# UNITED STATES PATENT AND TRADEMARK OFFICE

APPLICATION NO.	FILING DATE	FIRST NAMED INVENTOR	ATTORNEY DOCKET NO.	CONFIRMATION NO.
10/668,760	09/23/2003	James A. Mott	200209662-1	2551

**Office Action Summary**

## **DETAILED ACTION**

第 5 図

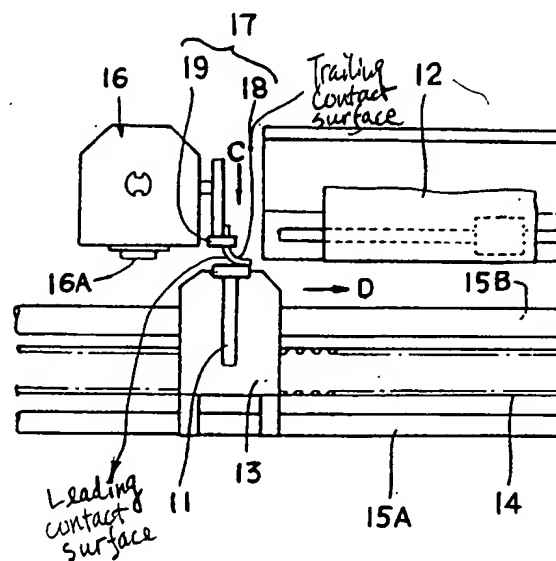
a wiper (18, figs. 1-5) having a leading contact surface and a trailing contact surface, the leading contact surface leads the trailing contact surface in a direction of wipe (indicated by arrow D in fig. 5) during wiping, refer to fig. 5 below for the leading contact surface and a trailing contact surface, and the direction of wiping; and

a capillary passageway (22, fig. 1, Miyagawa called it a slit, a slit a merely a narrow passageway having the function of channeling liquid or having a capillary character) in the wiper sized to allow capillary flow of a liquid along the capillary passageway by capillary forces, refer to page 5, lines 5-14 and page 7, lines 6-9.

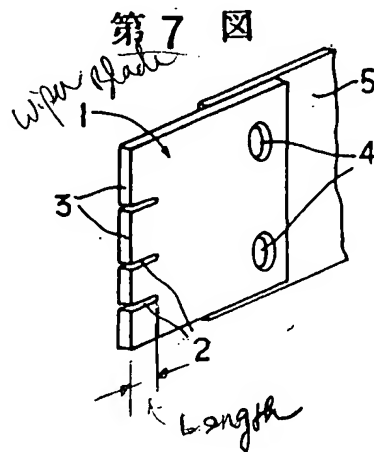
wherein the capillary passageway has a constant width, refer to fig. 7, in which, numeral 3 stands for slit, which has the same function as that of numeral 22 in fig. 1, also refer to page 3, lines 24-35.

wherein the length of the capillary passageway is oriented along an axis that is substantially parallel to the direction of wipe, refer to fig. 7 below.
